BROADVIEW ACCESS MANAGEMENT REVIEW

US 211/US17/29 BUS (BROADVIEW AVENUE), WARRENTON, VA

Date:	August 27, 2018	Project #: 21905
To:	Brandie Schaeffer, Town of Warrenton	
From:	Chris Tiesler, PE; Bradley Reynolds, PE; and Andy Butsick, PE

Figure
2

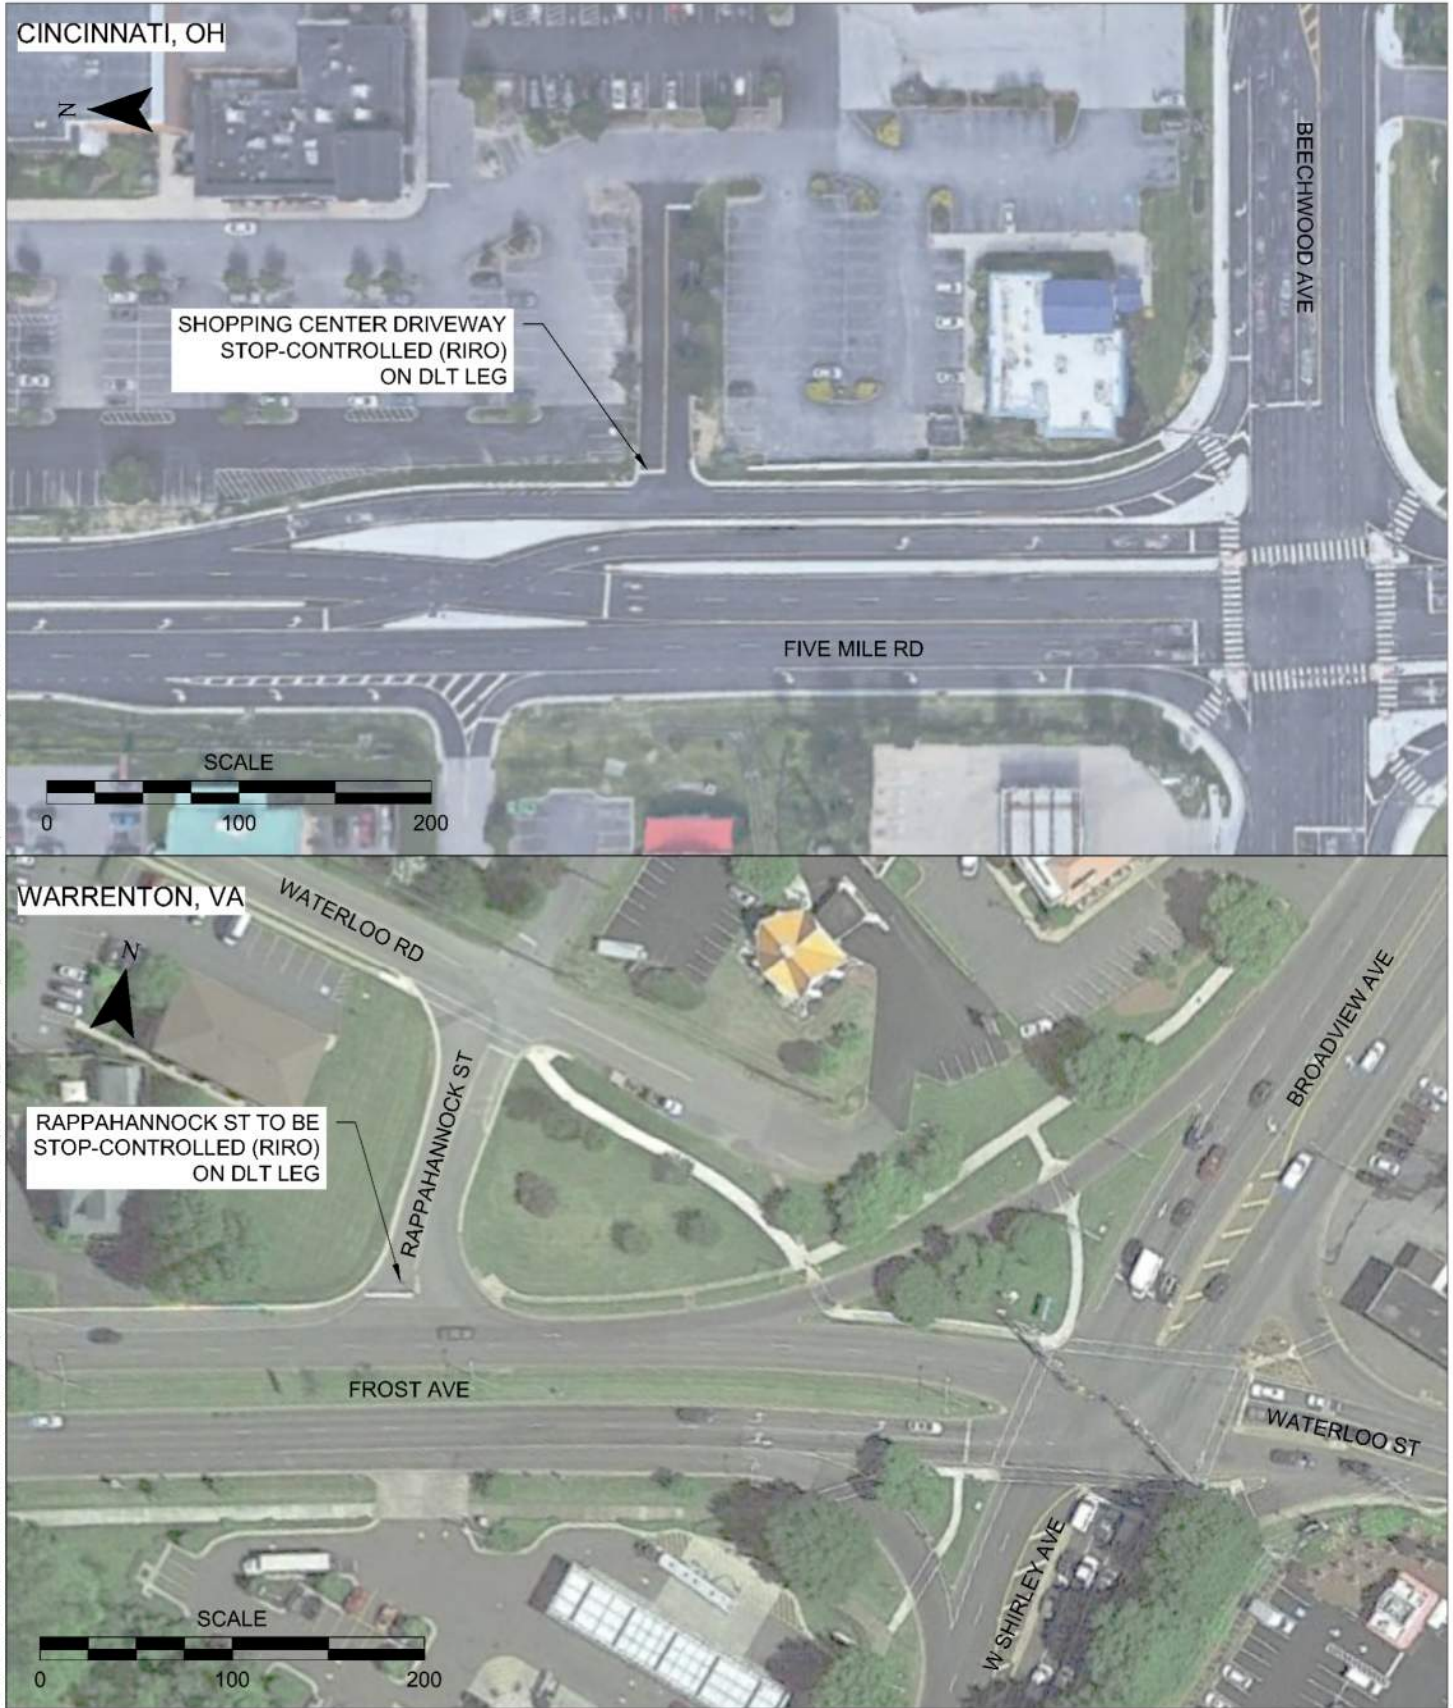
In **Appendix A, Figure 2** illustrates the partial displaced left-turn intersection preliminary concept (illustration does not reflect analyzed geometry). **Figure 3** shows an example of a similar partial displaced left-turn intersection at Beechmont Avenue and Five Mile Road in Ohio.

While a one-leg partial DLT intersection concept provides certain advantages, this alternative intersection design is not recommended for further study or implementation at this location due to the disadvantages and the ability of conventional geometric improvements to meeting desired project goals.
